SUBJECT: Forwards partial response to EG Tourigny 870716 request for
 addl info re 870612 application for amend to license. Util
 will respond to certain portions of request in near future.
 Phased response acceptable by NRC.
 See @ DRAWINGS

Re: St. Lucie Unit I
Docket No. 50-335
Spent Fuel Rerack

By letter dated July 16, 1987 (E. G. Tourigny to C. O. Woody) the NRC Staff requested additional information in the area of plant systems it needed to continue its review of this proposed license amendment.

FIGURE 1

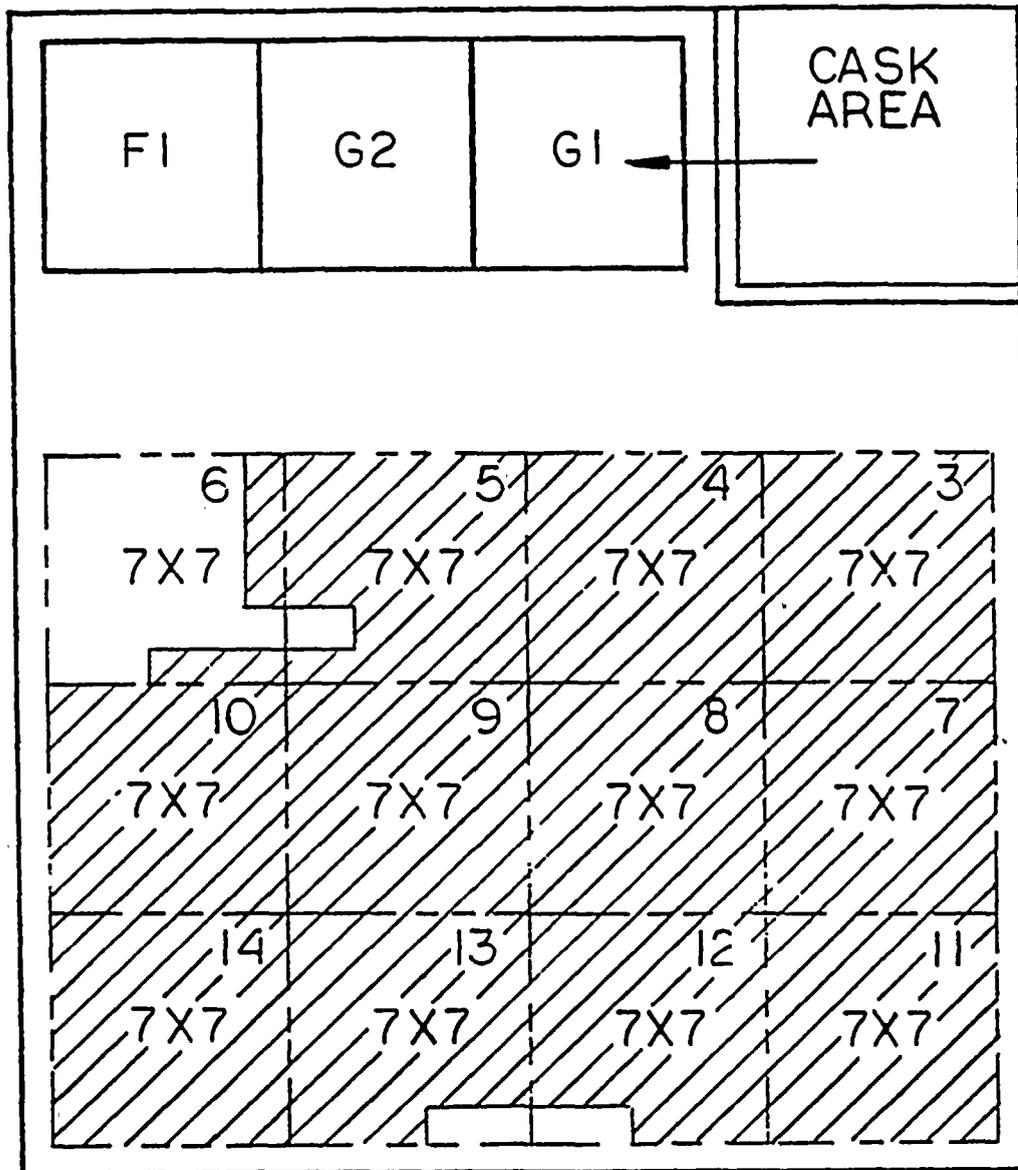
1. Following the removal plan (see question #5), remove Racks 1 and 2 from the pool as shown in Figure #1.
2. Following the installation plan (see question #5), install Racks F1-G2-G1 as shown in Figure #2.

FIGURE 3

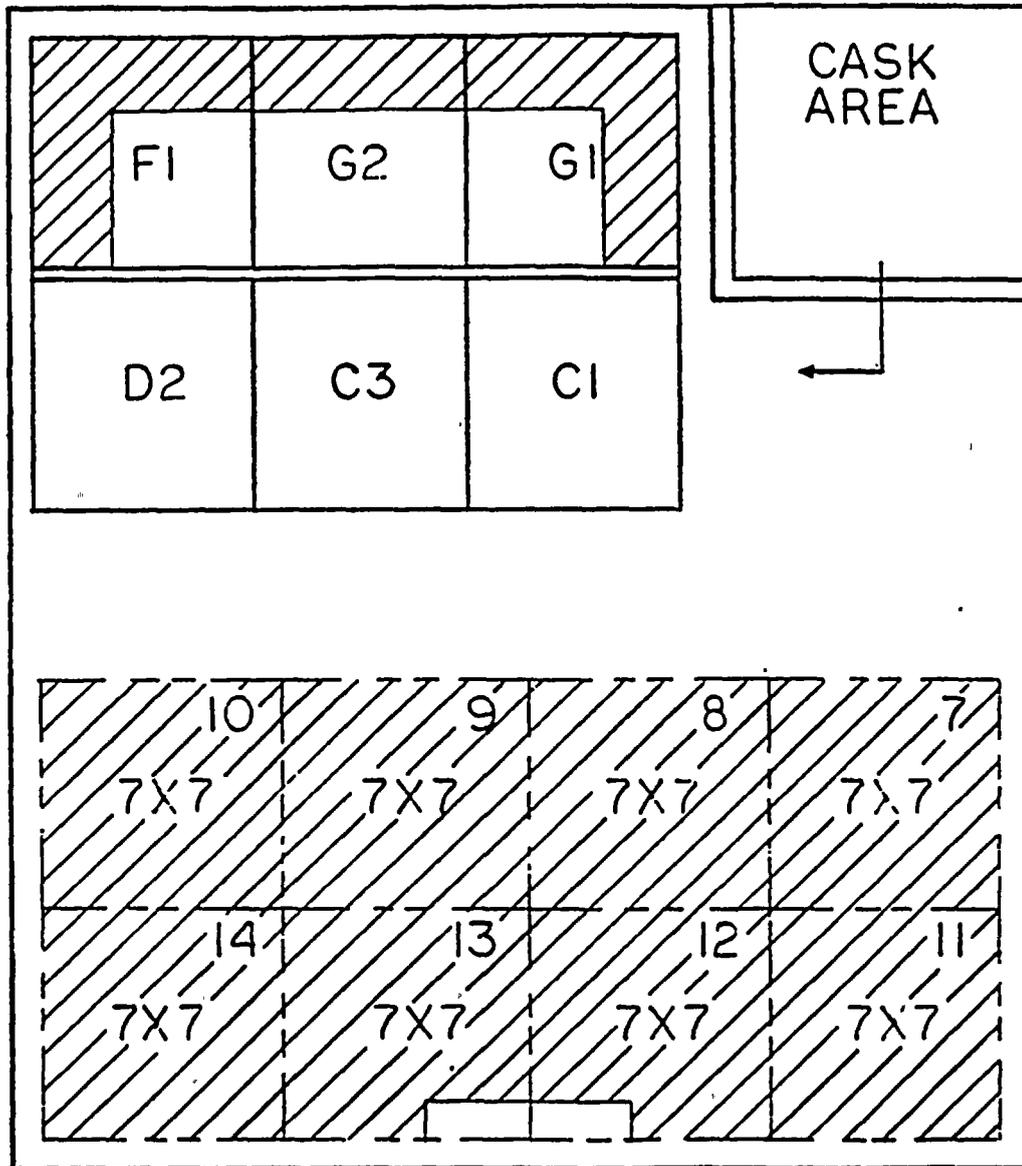
3. Relocate all of the 238 fuel assemblies stored in Rows "L through T" to new racks F1-G2-G1 as shown in Figure #3.
4. Following the removal plan (see question #5), remove all four racks, which are in Rows "L through T", removing 3, 4, 5 and 6 shown in Figure #3.

FIGURE 4

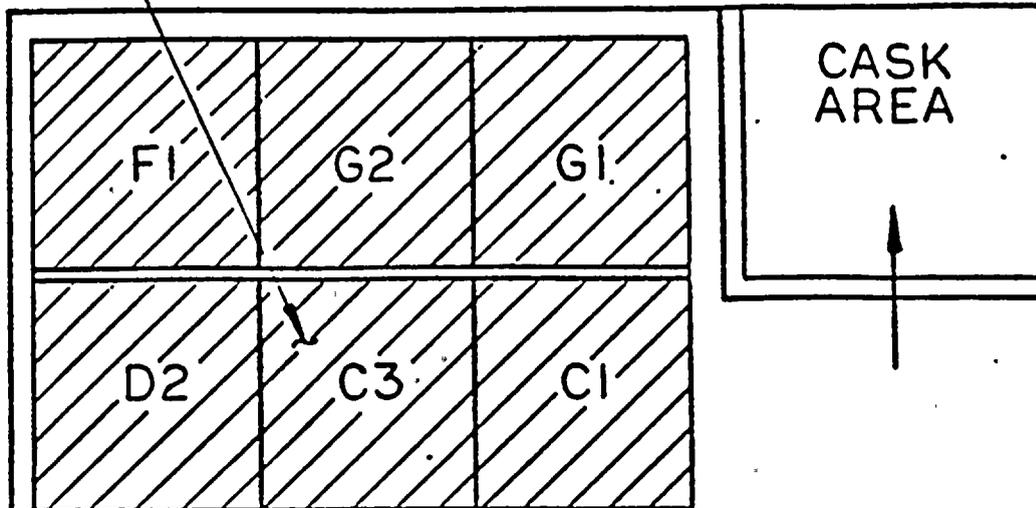
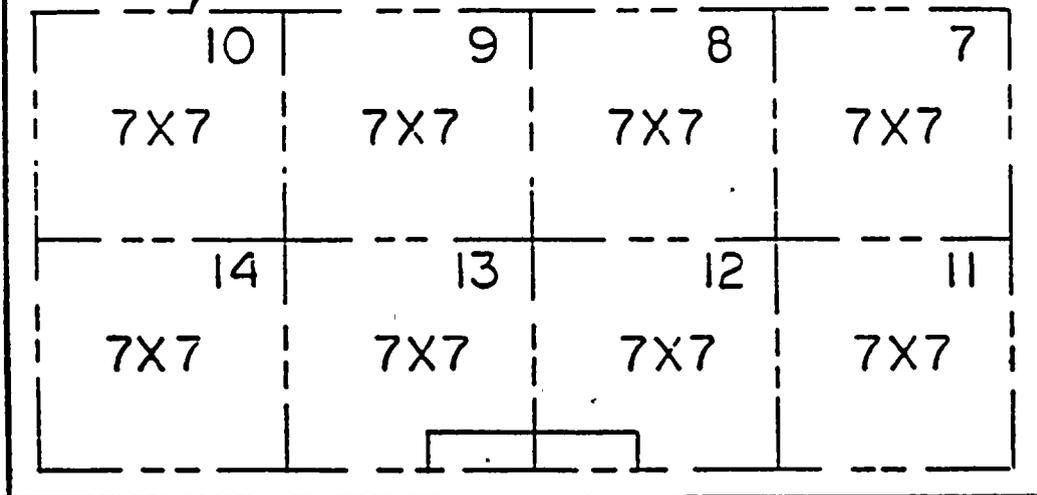
5. Following the installation plan (see question #5), install new Racks D2, C3, C1, as shown in Figure #4.
6. Relocate all the assemblies stored in old racks into new racks as shown in Figure #5.

FIGURE 5

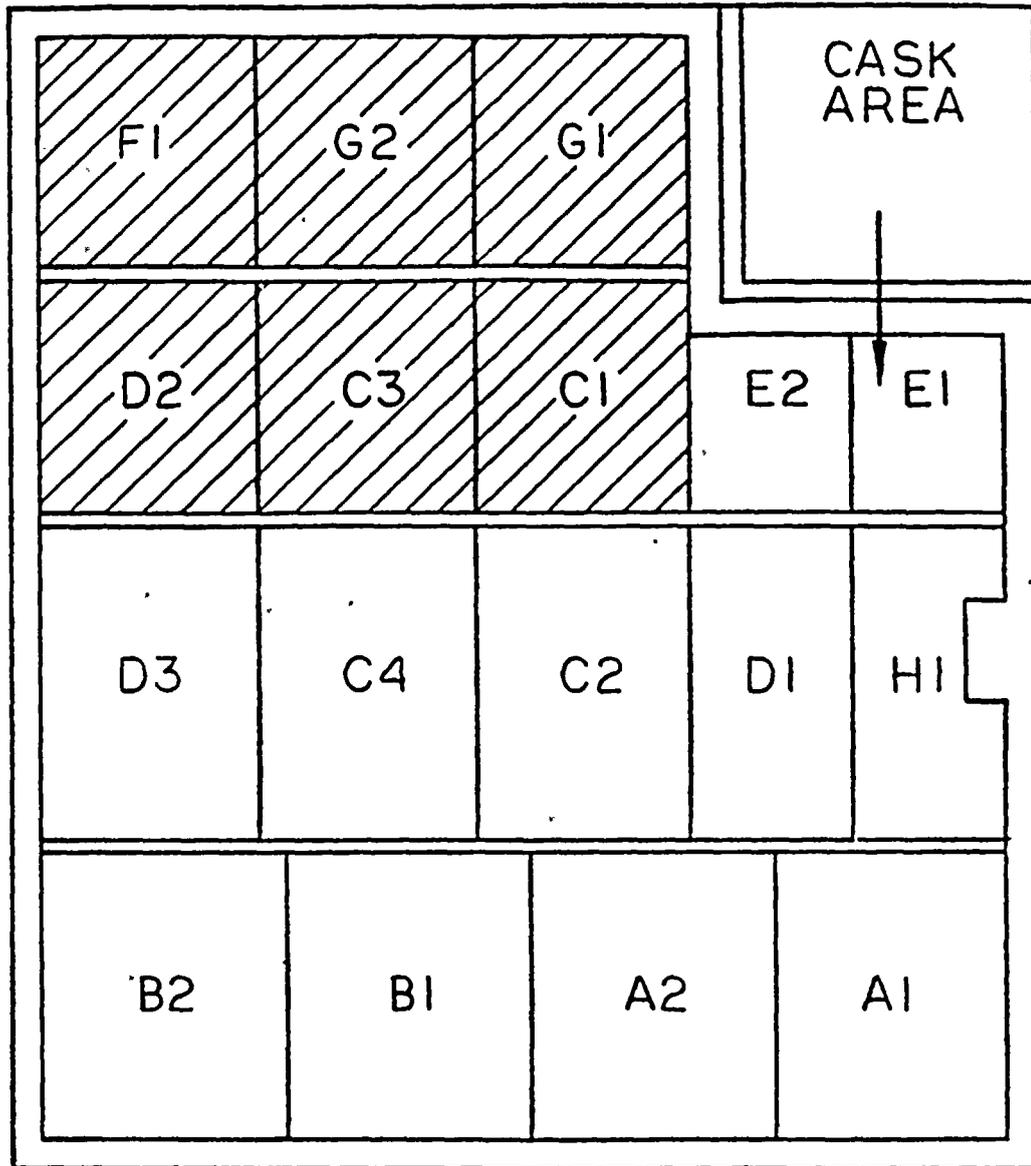
7. Following the removal plan (see question #5), remove all eight Racks 7, 8, 9, 10, 11, 12, 13 and 14 shown in Figure #5.
8. Following the installation plan (see question #5), install new Racks D3, B2, C4, B1, C2, A2, A1, D1, H1, E2 and E1 shown in Figure #6.

REV				DATE				BY				APPROVED				EBASCO SERVICES INCORPORATED				FLORIDA POWER & LIGHT COMPANY ST LUCIE PLANT 1976-890 NW ₆ INSTALLATION UNIT 1				SK-83-02- M-001	
																DIV 11C DR MM				APPROVED				GENNERAL ARRANGEMENT	
																DATE 8/21/87								FUEL HANDLING BUILDING PLAN

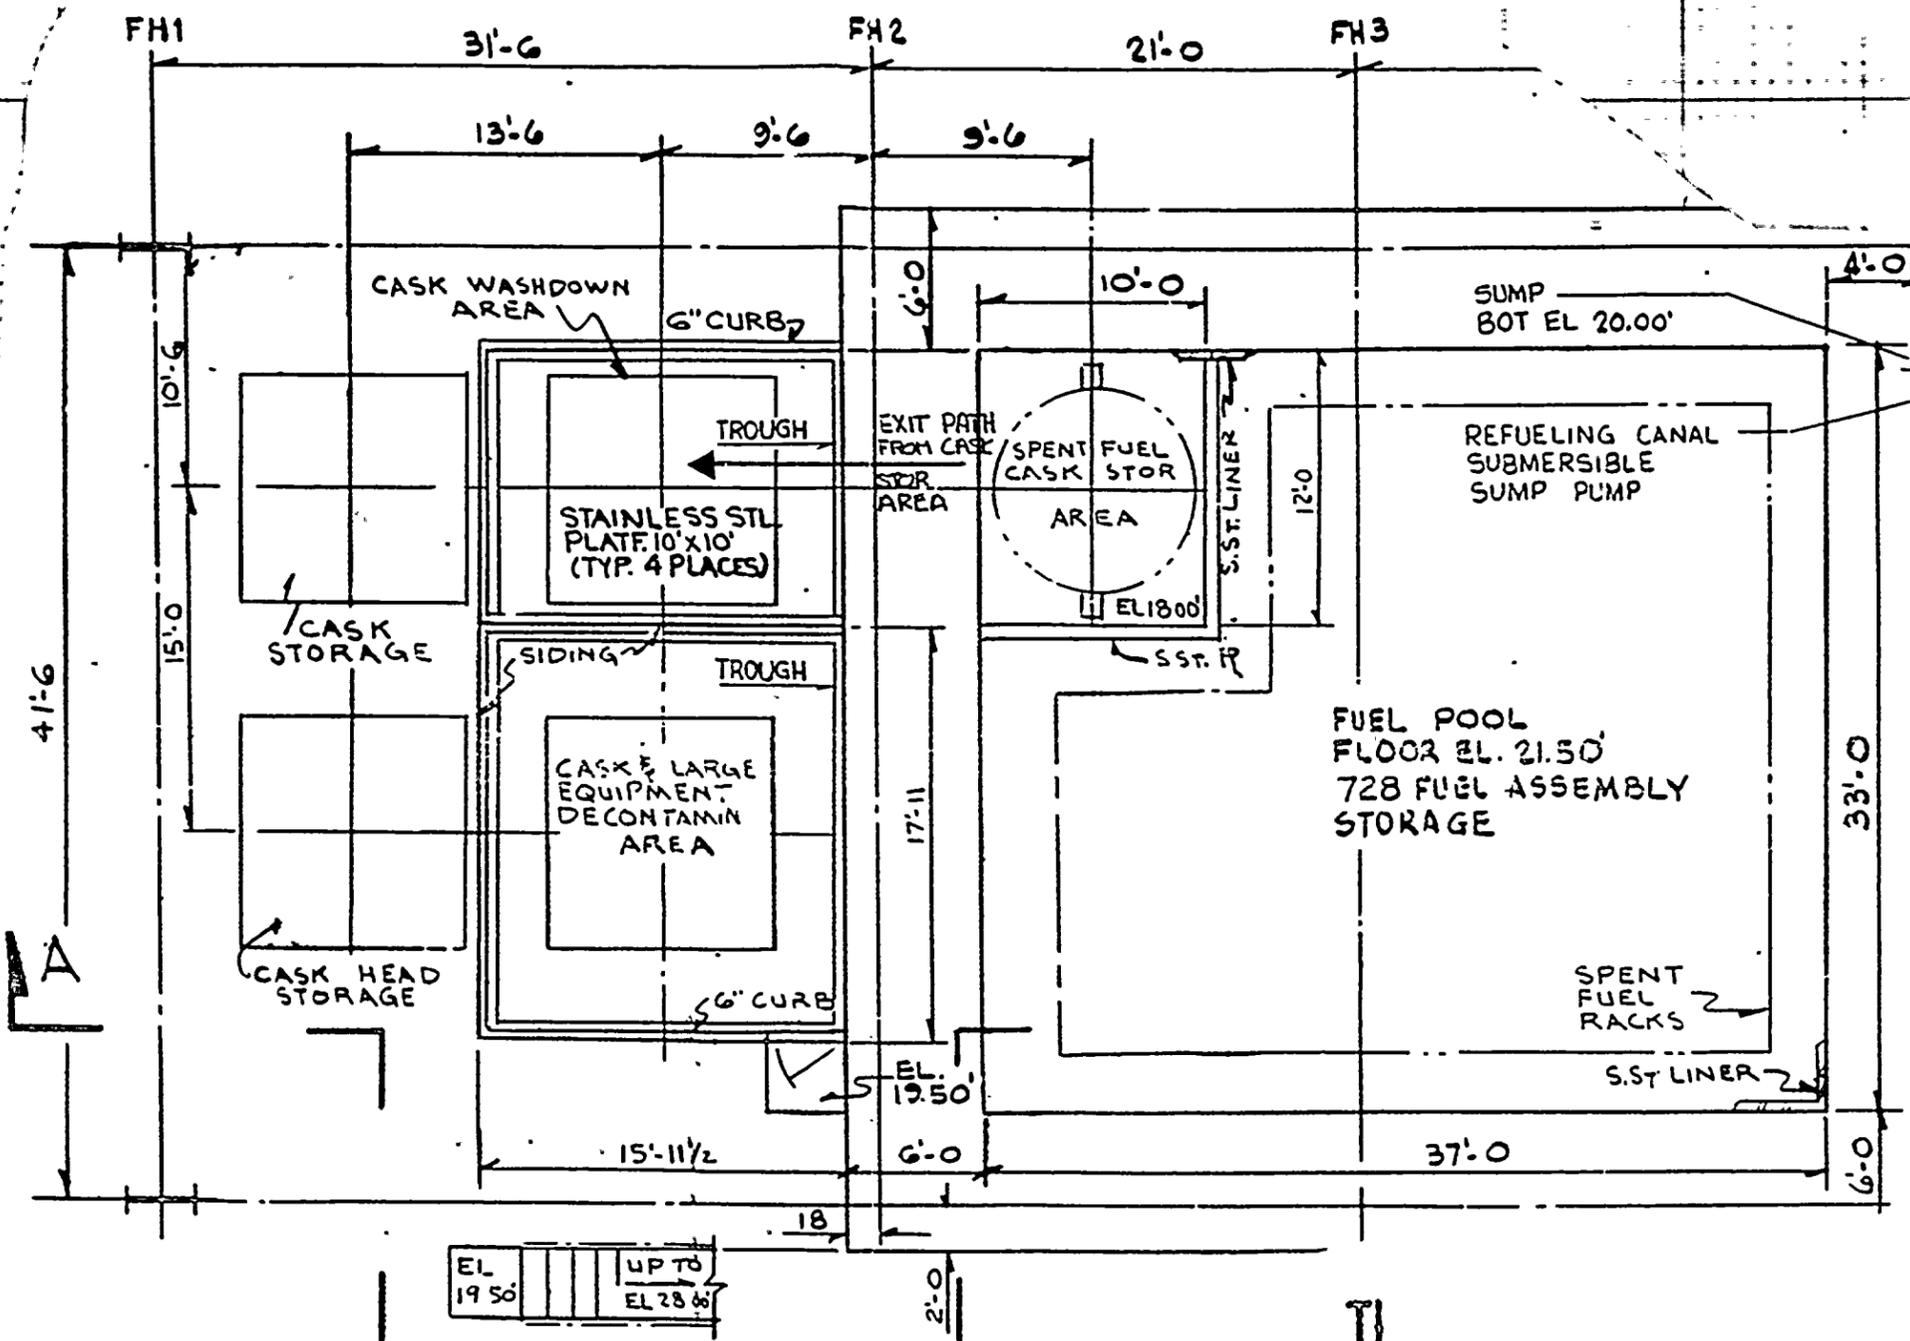
QUESTION: Provide drawings which show the movement of both the existing and the new racks throughout their entire path of travel from outside of the fuel handling building until their final location in the spent fuel pool (and the reverse for the existing racks).

RESPONSE: For the removal of the racks from the spent fuel pool cask storage area to outside the spent fuel pool (see General Arrangement sketch SK-83-02-M-001 attached) each rack module will be removed individually following a path that does not carry the rack over any other racks containing spent fuel (see response to question number 6). Each rack module will be removed by crane and transported over a prescribed path to the spent fuel cask storage area. The old racks will be washed down and dried. The dried racks will then be placed in polyethylene bags and removed to the cask equipment decontamination area. The polyethylene bags will be removed and discarded and the racks will be cleaned until desired results are achieved. The racks will be inserted in clean polyethylene bags and moved to a designated rack storage area on site.

For installation of the new spent fuel racks the racks will be brought from their onsite storage location to the cask washdown area and cleaned as required. After cleaning is complete each rack module will be transported into the spent fuel cask storage area. From the spent fuel cask storage area the module will be transported over the spent fuel pool (see response to number 6) to its proper location, where it will be placed. During the process the racks will not be carried over racks containing spent fuel.
